**TSG-RAN Meeting #13
Beijing, China, 18 - 21 September 2001**

RP-010538

Title: Agreed CRs (Release '99 and Rel-4 category A) to TS 25.303

Source: TSG-RAN WG2

Figure 34: Combined Cell/URA Update and SRNS relocation (lossless radio bearers)

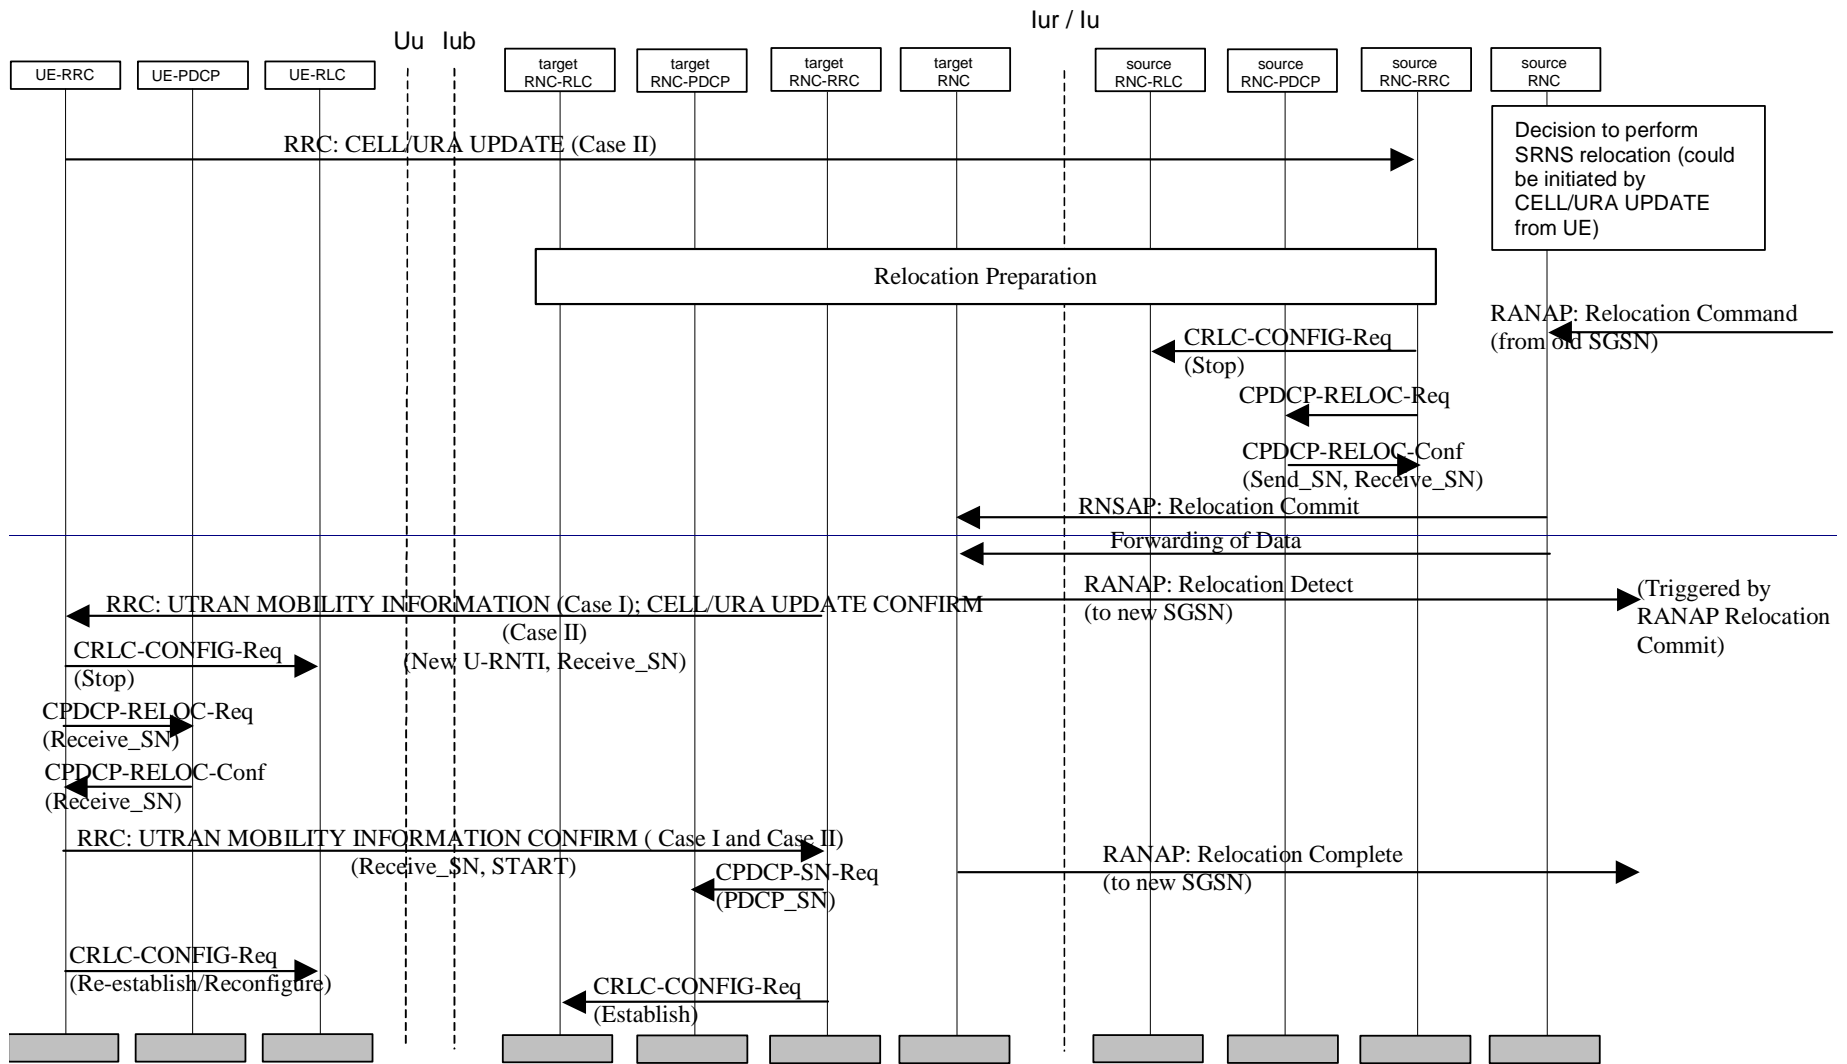
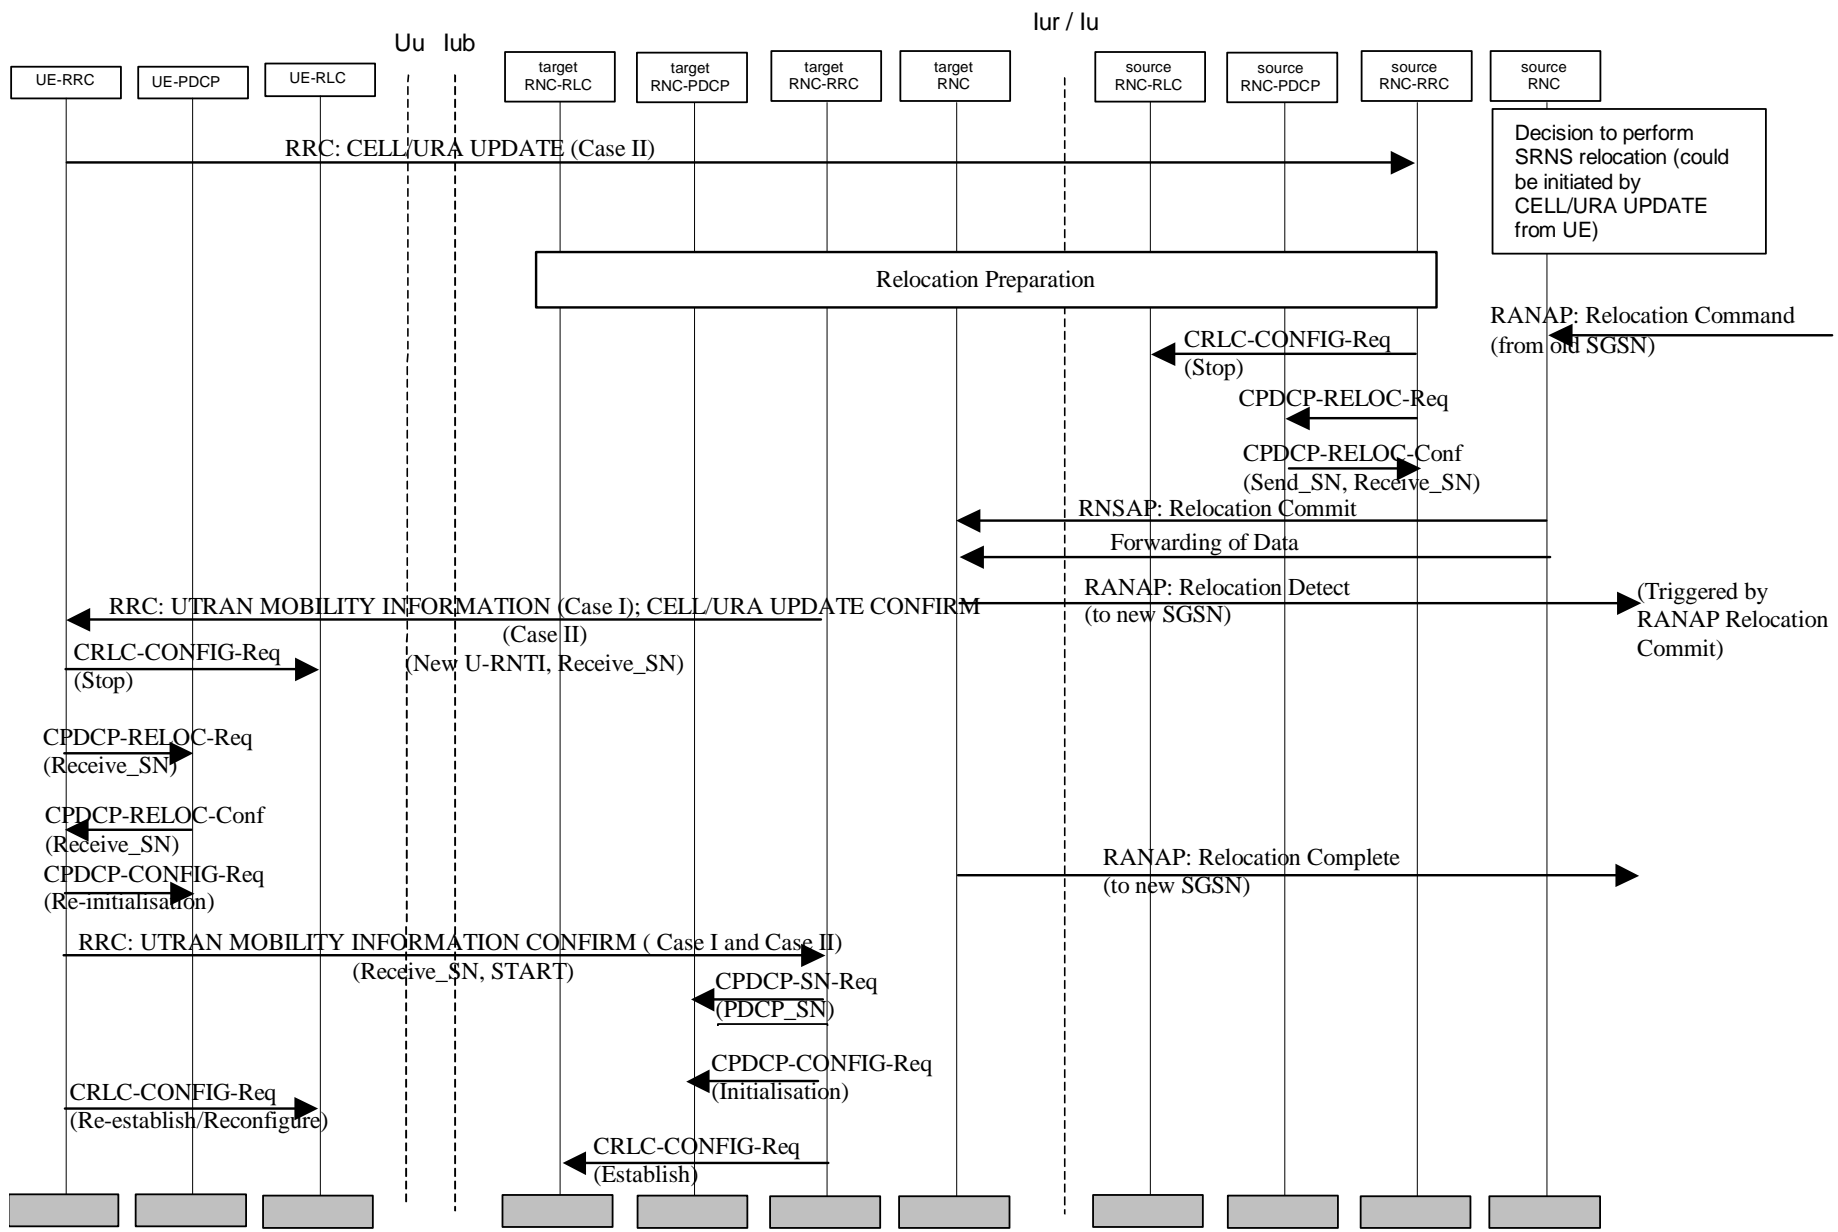
Reason for change:	⌘ As described in Tdoc R2-010896 presented during RAN WG2#20, currently, the handling of PDCP Header Compression protocol during SRNS relocation is not described in the TS.
Summary of change:	⌘ A new parameter in the CPDCP-CONFIG primitive between PDCP and upper layers is proposed to be has been defined in a companion draft CR to 25.323 and is used to reinitialise the entire context at the decompressor during SRNS relocation when Header compression is used. This is applicable for lossless, lossy and seamless radio bearers. <u>Isolated impact analysis:</u> The CR contains a correction to a function where the specification was: <ul style="list-style-type: none"> • ambiguous or not sufficiently explicit. The proposed changes do not change the behaviour, since the inter-layer procedure examples in 25.303 are informative only.
Consequences if not approved:	⌘ Description of header compression reinitialisation during SRNS relocation will not be complete.

The target RNC then sends a UTRAN MOBILITY INFORMATION (Case I) or a CELL/URA UPDATE CONFIRM (Case II); which configures the UE with the new U-RNTI and indicates the uplink receive PDCP sequence number for each radio bearer configured to support lossless SRNS relocation. The UE compares the uplink receive PDCP sequence number with the UE uplink send PDCP sequence number. If this confirms PDCP SDUs successfully transferred before the start of relocation i.e. already received by the source RNC then these are discarded by the UE. [The UE reinitialises the PDCP header compression entities of the radio bearers configured to use a header compression protocol \[7\].](#)

Figure 35: Combined Hard Handover and SRNS relocation (lossless radio bearers)

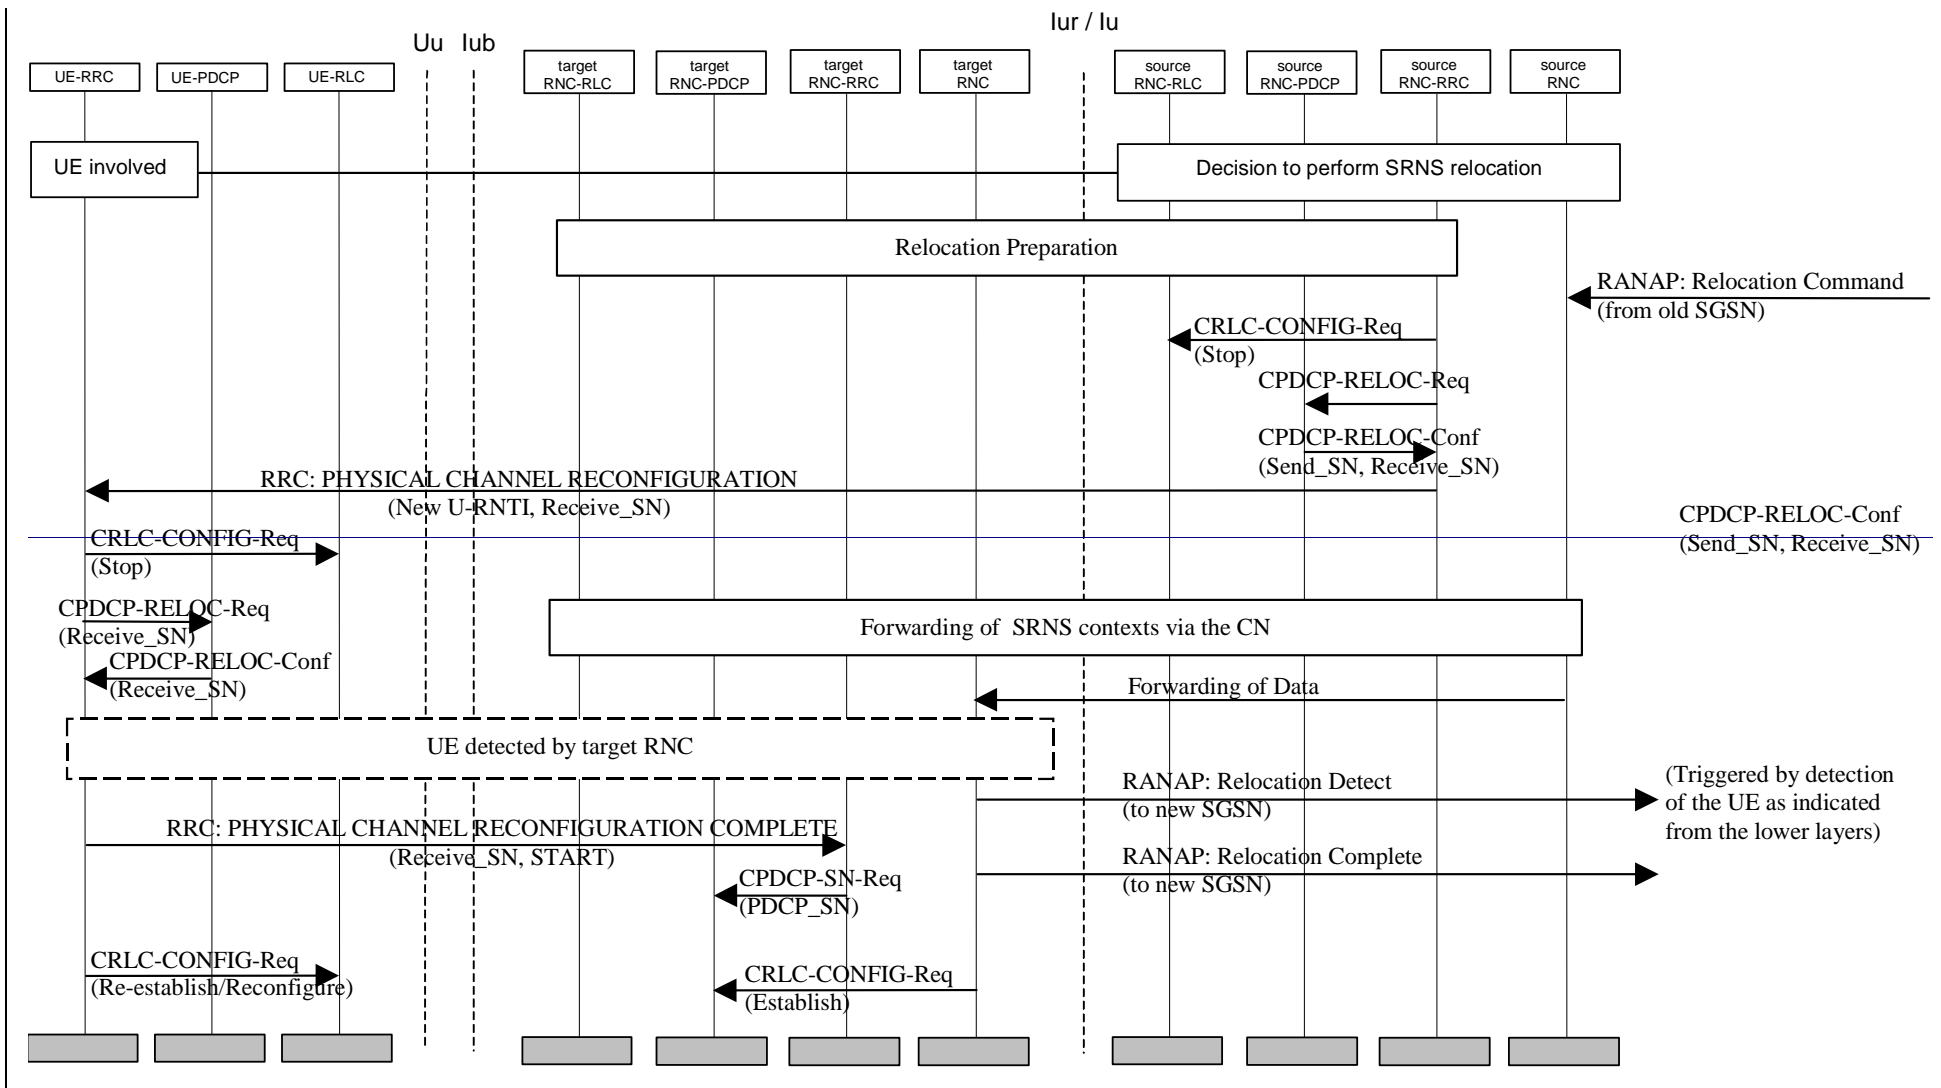
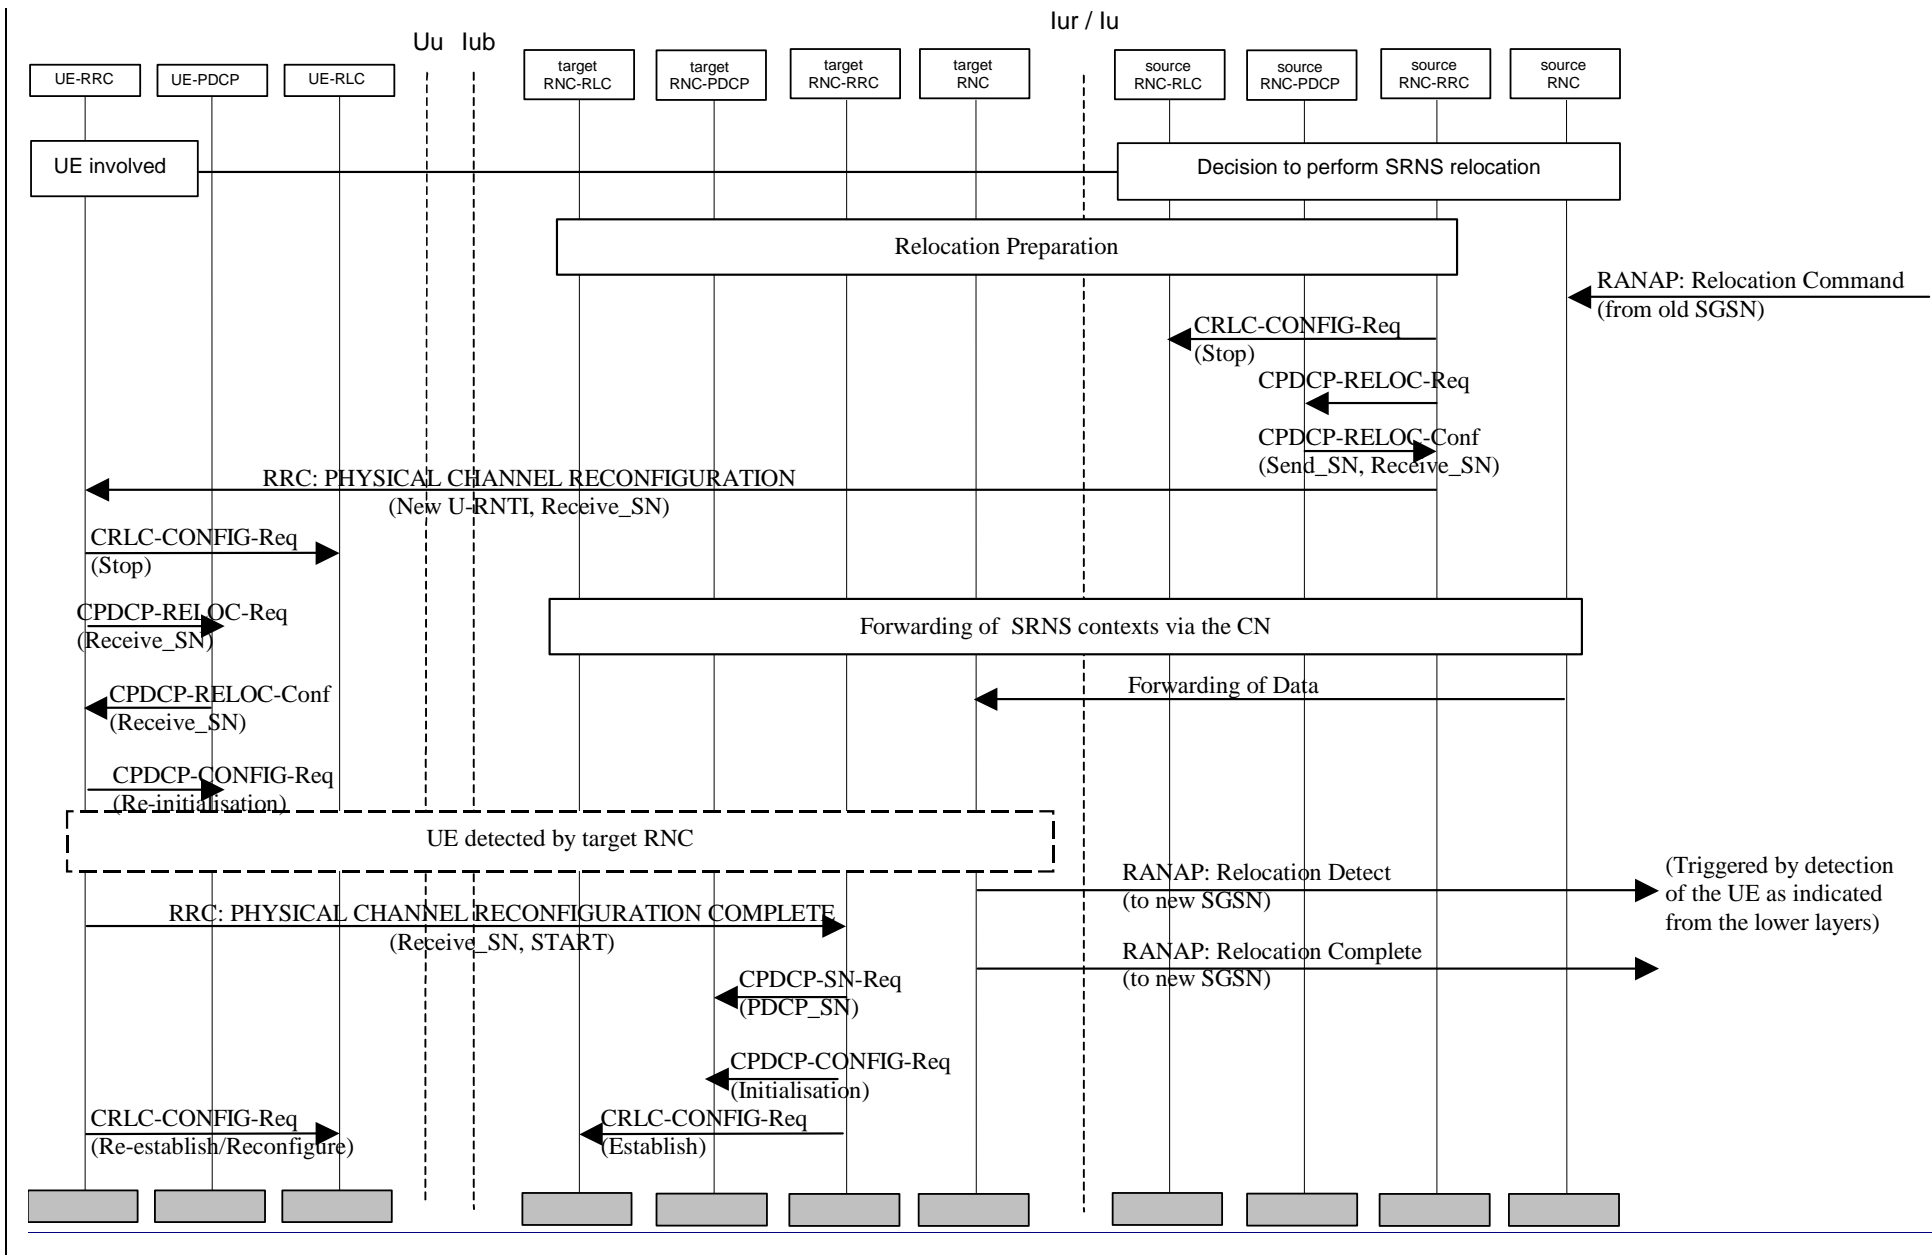
The Target RNC to Source RNC Transparent Container includes the RRC message (e.g. PHYSICAL CHANNEL RECONFIGURATION) for hard handover. Upon reception of the RANAP Relocation Command, the source RNC triggers the execution of the relocation of SRNS by sending the RRC message to the UE. This message includes the new U-RNTI and the uplink receive PDCP sequence number for each radio bearer configured to support lossless SRNS relocation. The UE compares the uplink receive PDCP sequence number with the uplink send PDCP sequence number. If this confirms PDCP SDUs successfully transferred before the start of relocation i.e. already received by the source RNC then these are discarded by the UE. The UE reinitialises the PDCP header compression entities of the radio bearers configured to use a header compression protocol [7].
